NOTICE OF VIOLATION

Consumers Power
Company

Docket No. 50-329
Docket No. 50-330

SUBJECT: NRC Midland Project, Request for Additional Borings and Existing
Soil Data - Revision No. 1

Questions on NRC Review Policy of Cooling Ponds (Cat. II)

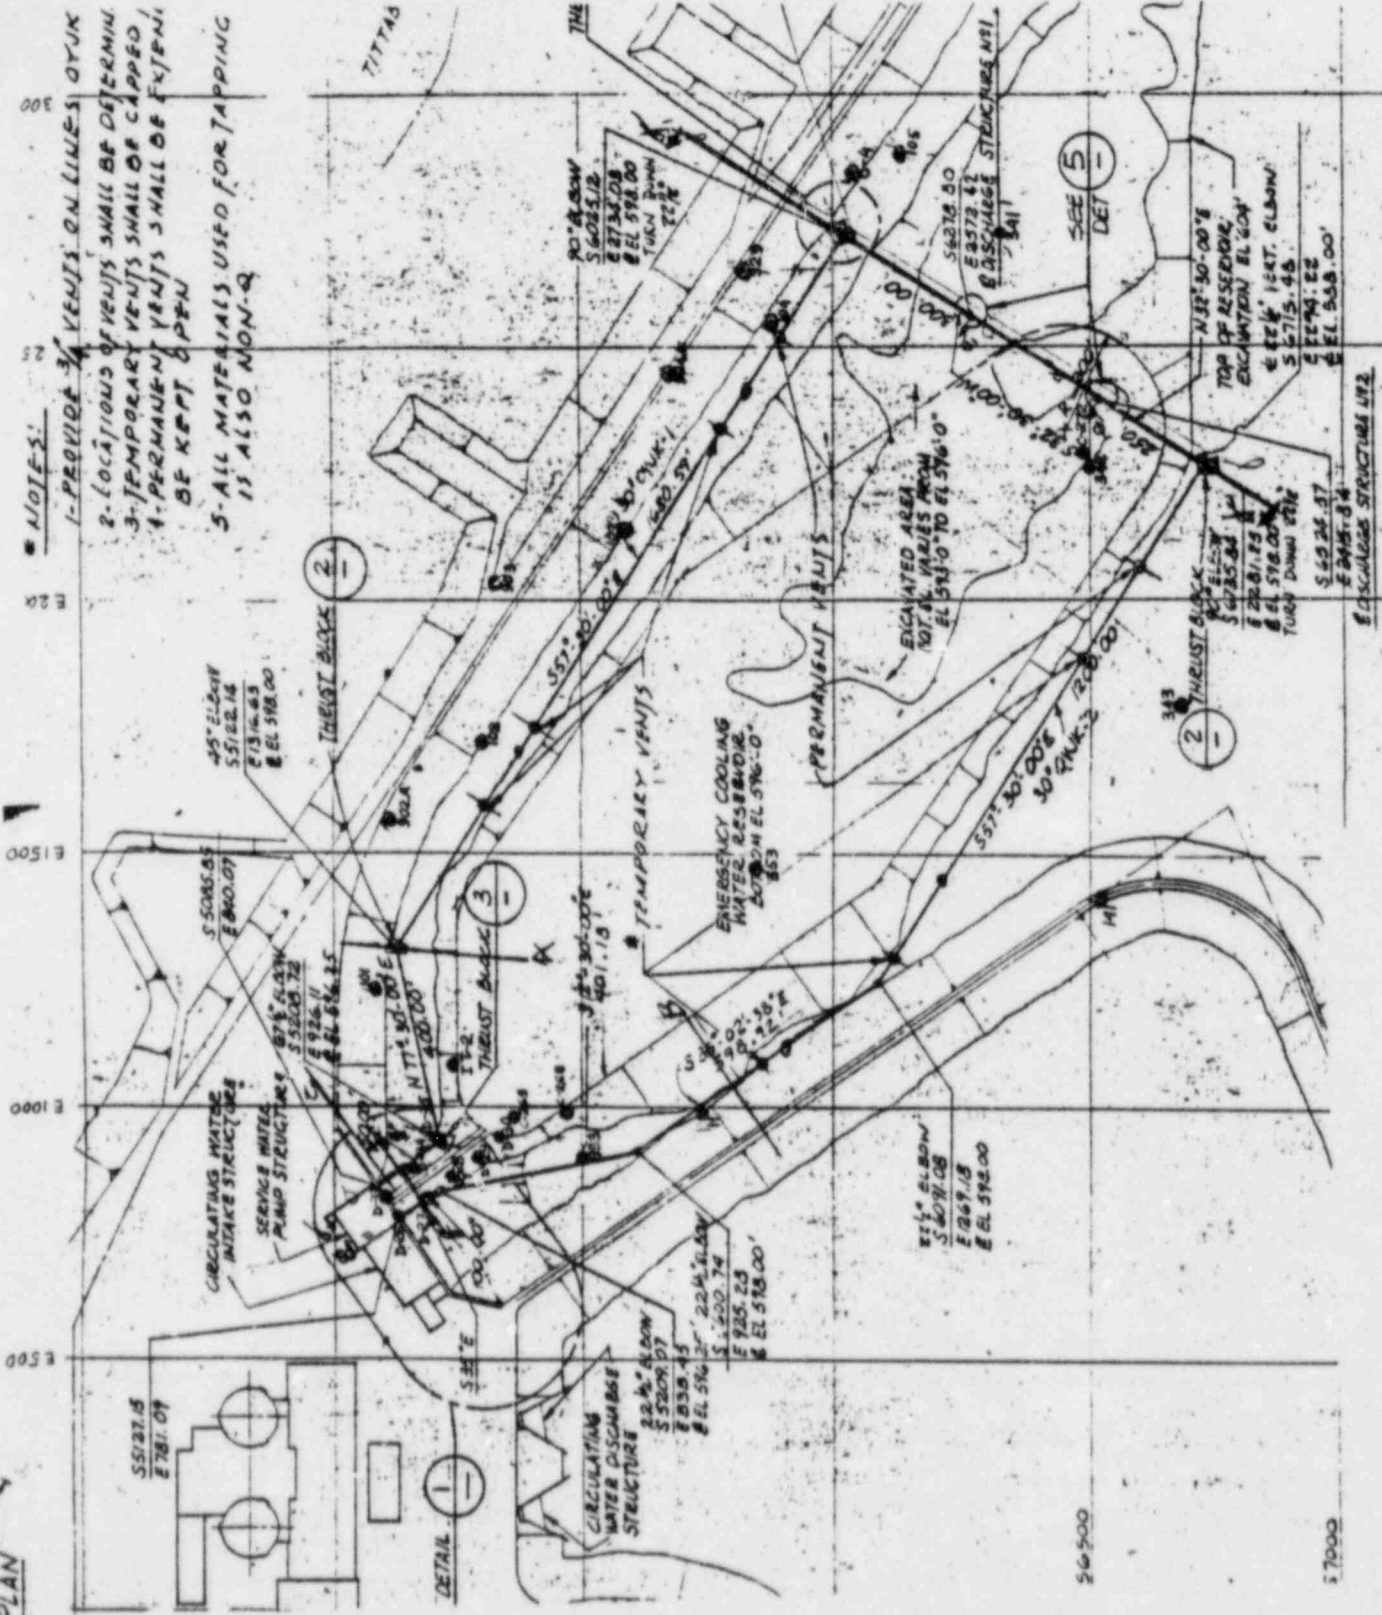
request for add'l. explorations in cooling pond dike system
to Jun. 13, 1980 Memo, Knight to Tedesco)
has indicated the following reasons for request:
concern for dike stability & pond seepage & emergency access
& fill that constitutes pond dikes is same type & probably
caused same compaction effort as plant fill now experiencing
a settlement problem. (Concern for dike adequacy & chance
increase knowledge on problem plant fill)

the position of Cat. I pipeline at tee of dike, a partic
ular Pond Embankment System & its stability would
result in determination that dikes in this portion are
Cat. I

As stated to be Cat. II, the Applicant has presented
a stability analysis of the cooling pond dike
. Does NRC in our review ignore the information
presented in the FSAR?

Plant Area Boring P

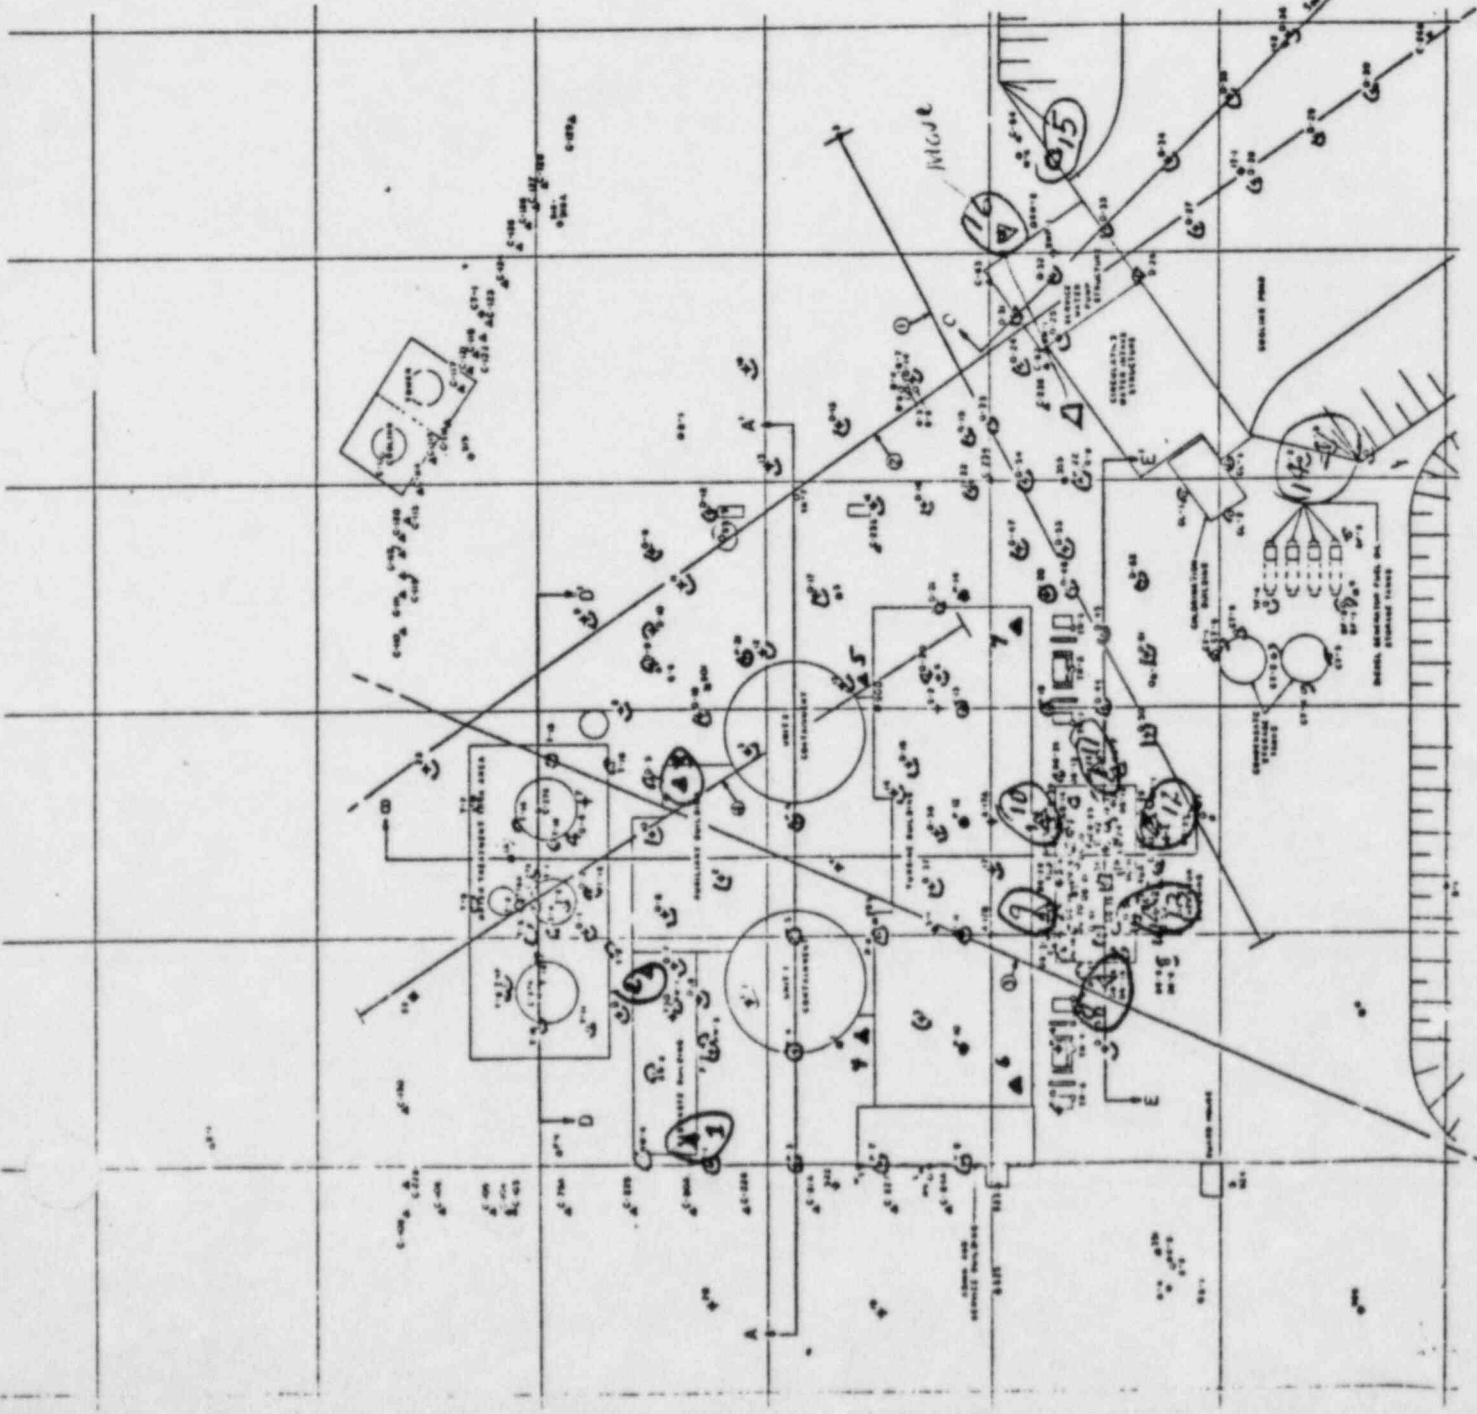
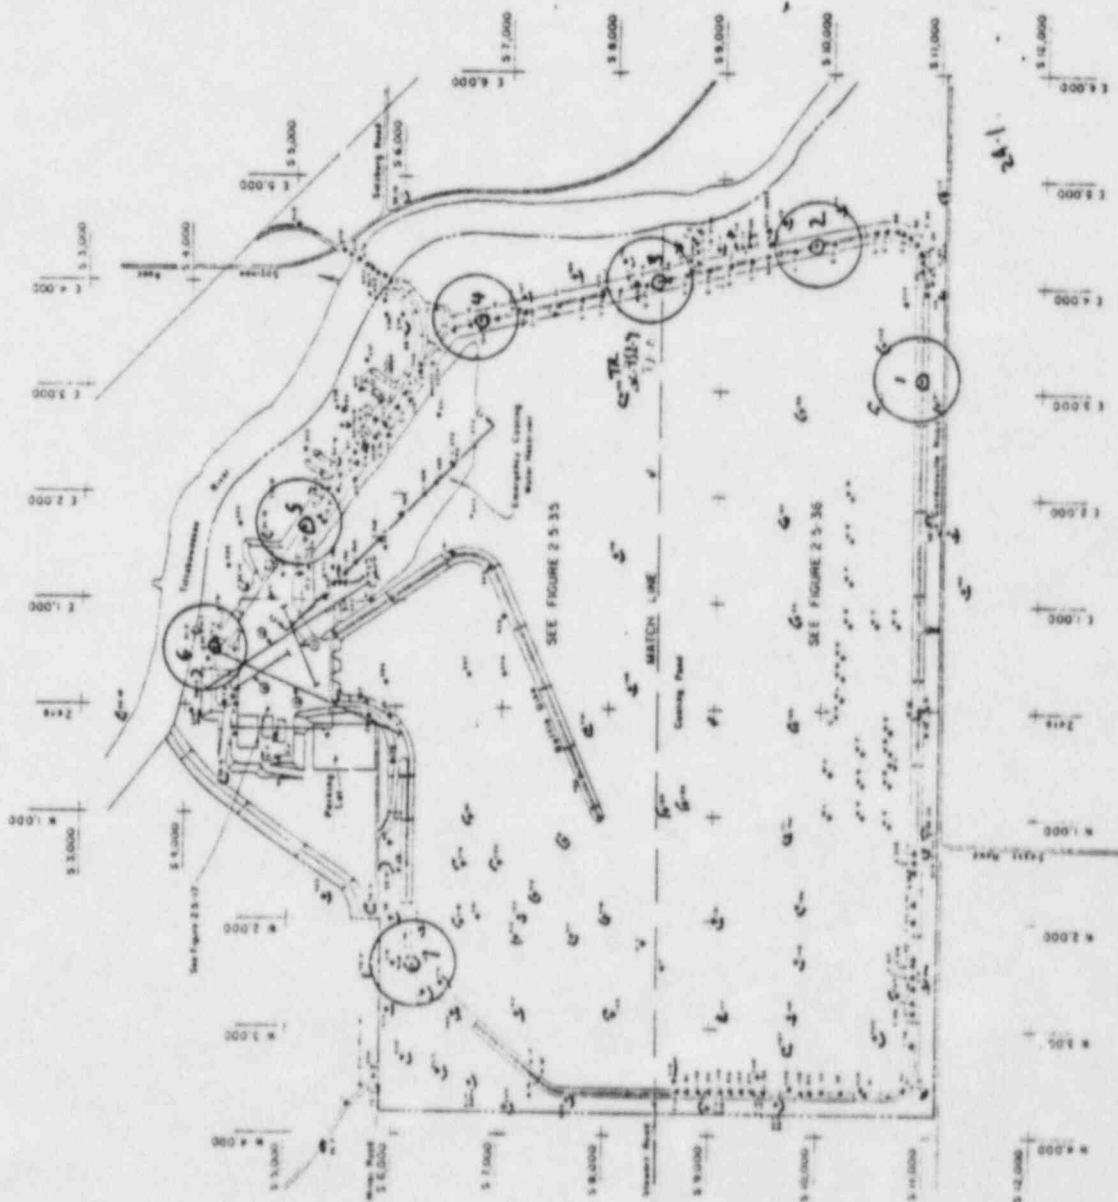
7. A need exists for additional borings, since random exploratory borings throughout the plant site have revealed pockets of soft clay subject to settlement and or consolidation and loose sands subject to liquefaction. A need also exists to check the results of the proposed remedial measures of surcharge loading at the Diesel Generator Building and the dewatering plan.

a. In the case of the Diesel Generator Building, check borings must be made in the vicinity of borings which identified low "N" values in the clay and sand fill. The proposed borings shall be carried into the glacial till and all samples, including those in the glacial till, tested as indicated below.

a. Diesel Generator Building - 4-6 holes around the perimeter of the building. Samples of all strata from ground surface into the glacial till (Holes 3-13). Include downhole, crosshole and surface geophysical tests to establish insitu compression and shear moduli for floor response spectra design check mentioned on pg. 18 Q VII-4 of Interim SER. 11/21/78 by NRC

b. Auxiliary Building - Take two borings around the proposed support piling or caisson for remedial grouting of loose sands and soft clays adjacent to pile or caisson to stiffen piles and adjoining ground against lateral loading. Borings need to penetrate ^{a minimum of 5 feet into} glacial till. (see attached map for boring locations - Holes 4 & 5.)

c. Service Water Building - A boring (Hole 16) shall be made as indicated on the attached map to and into the glacial till. All samples obtained shall be classified according to the Unified Soil Classification System also consolidation, drained and undrained triaxial compression tests made on cohesive soil samples and direct shears for a loose and dense condition shall be made on all granular soil samples, as specified in paragraph 7B.

d. Plant Area Borings - ^{If not Cat. I - will log} IF feasible some borings should be taken under the Radwaste and Turbine Buildings to determine if unwatered pockets exist or persist. Suggested boring locations would be as indicated on the attached map. Further investigation could be needed after the results of these borings are obtained. No borings presently exist in these areas. The borings should be cased or hollow stem auger borings with drive samples every 2-1/2 feet through the fill. ~~The holes should be converted to dewatering holes or used for piezometers (Holes 1, 2, 3, 6 & 7).~~ Deleted per Ron Erikson on 4/21/80

e. The site visit of 27 or 28 February 1980 turned up two differential settlement points on the retaining wall adjacent to the Service Water Pump Structure. Two borings, Holes 14 and 15 as indicated on the attached map shall be taken to investigate this problem. Tests required are consolidation tests, triaxial ^(RES) compression tests, Atterberg limits and gradation tests made on cohesive soils, and direct shear for loose and dense conditions and gradation tests made on granular soils. Settlement & re-check on wall stability
